ASSESSMENT REPORT

Berry and Walker Streets, North Sydney MP 08_0238 MOD 6

This report is an assessment of a request to modify the Project Approval (MP 08_0238) for the construction of a commercial tower at 77-81 Berry Street, North Sydney in the North Sydney local government area.

Figure 3: Approved (top) and proposed (bottom) lower ground level layout (Sources: MP 08_0238 MOD 5 and Proponent's application)

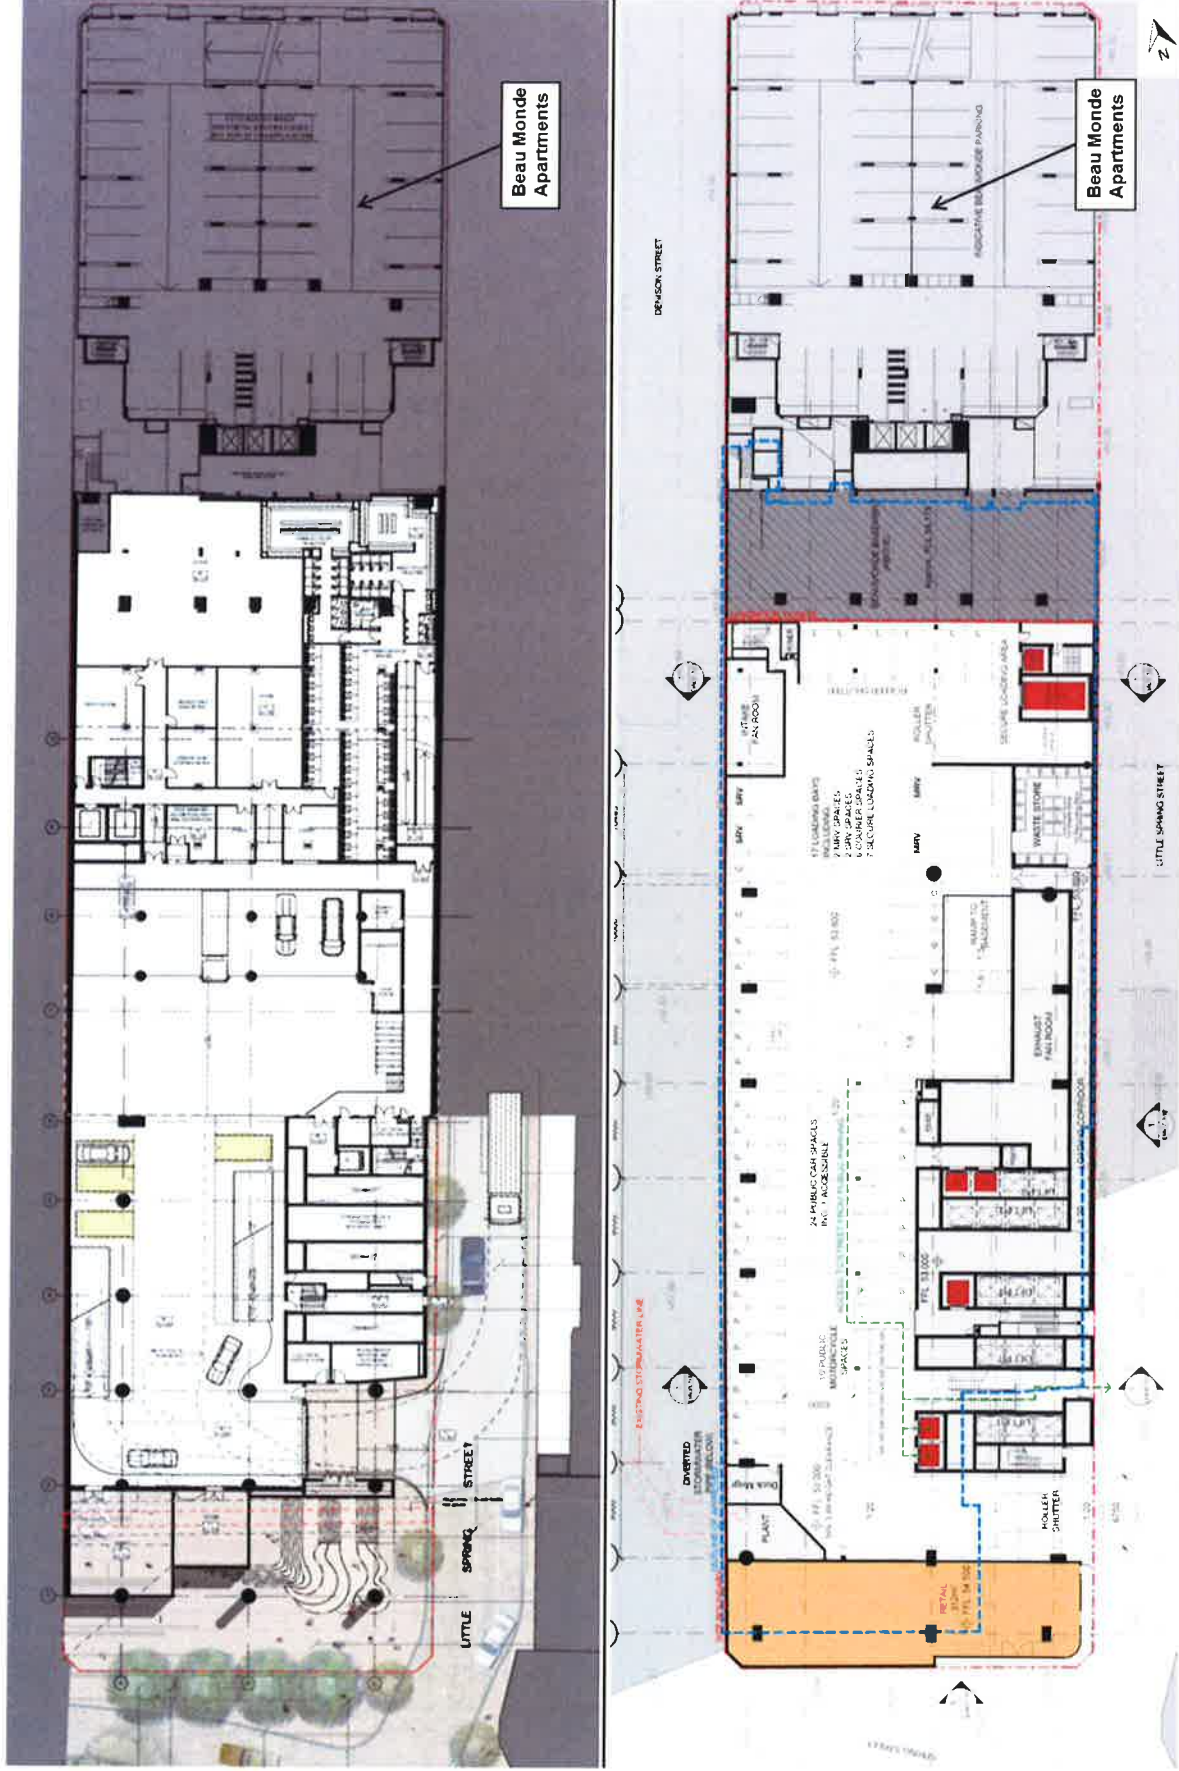
The modification is requested in order to provide a more efficient basement layout and to facilitate an enlarged and amended development as envisaged under the concurrent modification request MP 08_0238 MOD 7. The modifications are shown at **Figures 3 and 4**.
